TO: Members of the MAG Standard Specifications and Details Committee

SUBJECT: MEETING NOTIFICATION AND TRANSMITTAL OF TENTATIVE AGENDA

MAG Standard Specifications and Details Committee
TENTATIVE AGENDA
July 6, 2016

DETAIL NO.
319

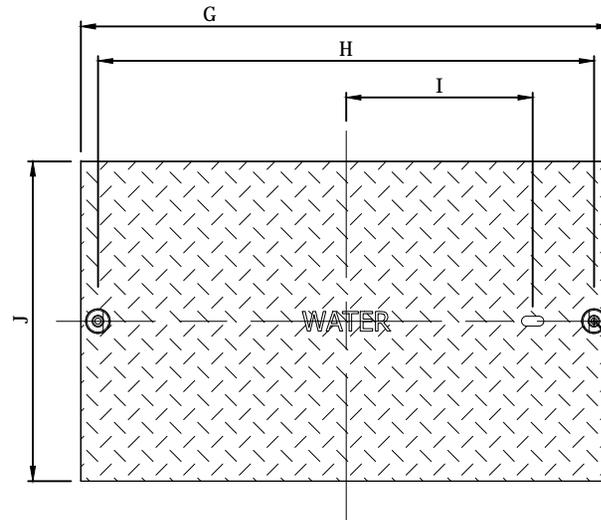
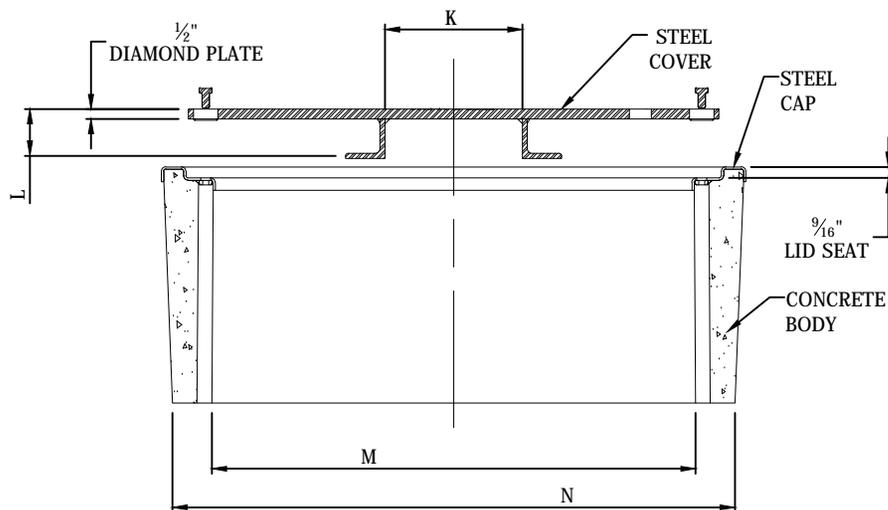
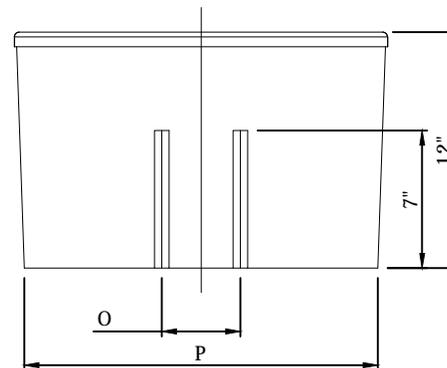
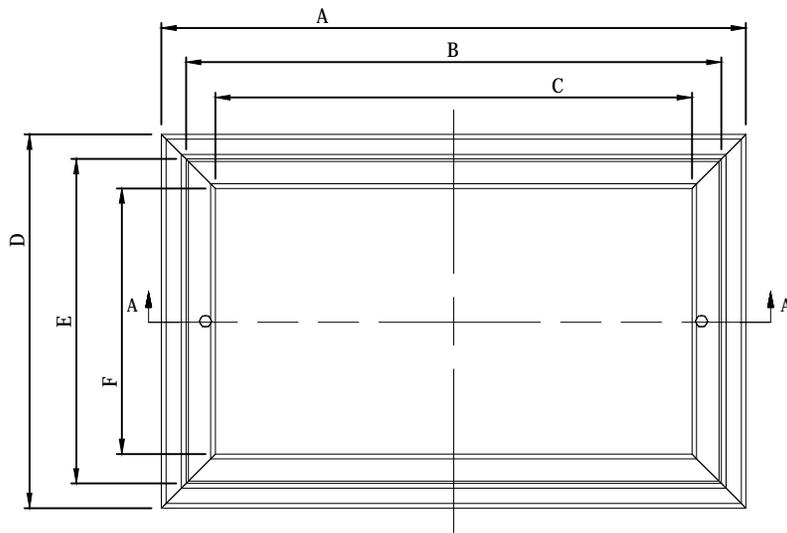
Mr. Sitarz also provided copies of Case 16-15 for traffic-rated boxes and covers (Detail 319). Ms. Erickson noticed that there was a typo for the AASHTO reference in Note 1. They are designed to meet H20 rating. Mr. Sitarz said he would make revisions to the details as suggested and provided them to Mr. Tyus for the next agenda packet.

- Revision to note 1, adding Lid and Box combination must meet AASHTO H20.
